Author Response to the referee comments on “Citizen rain gauge improves hourly radar rainfall bias correction using a two-step Kalman filter”

Responses to Editor

Responses to referee #5

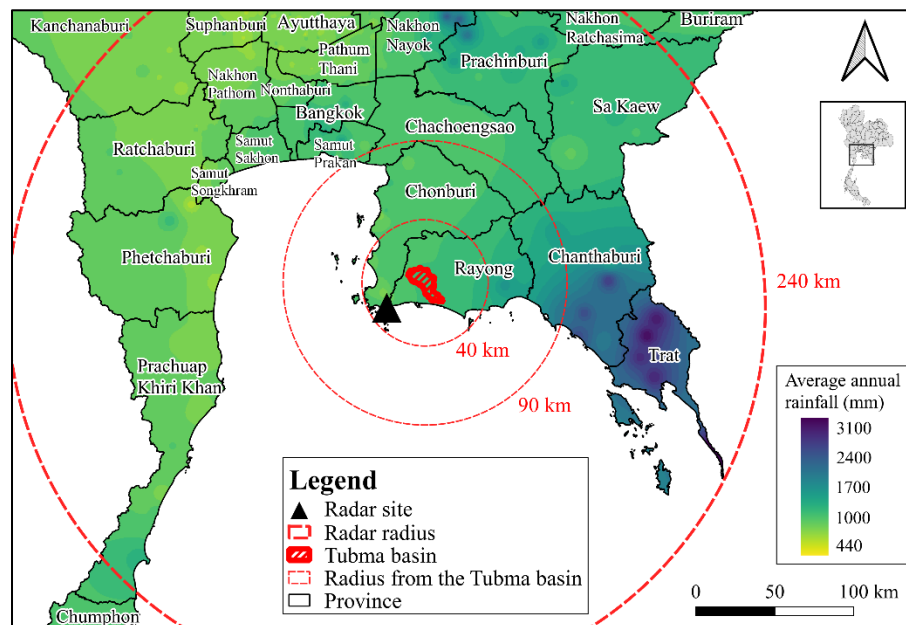
RC (2): Equation 1 can be deleted as it is already mentioned in the introduction.

AR: Equation 1 was deleted in the revised manuscript.
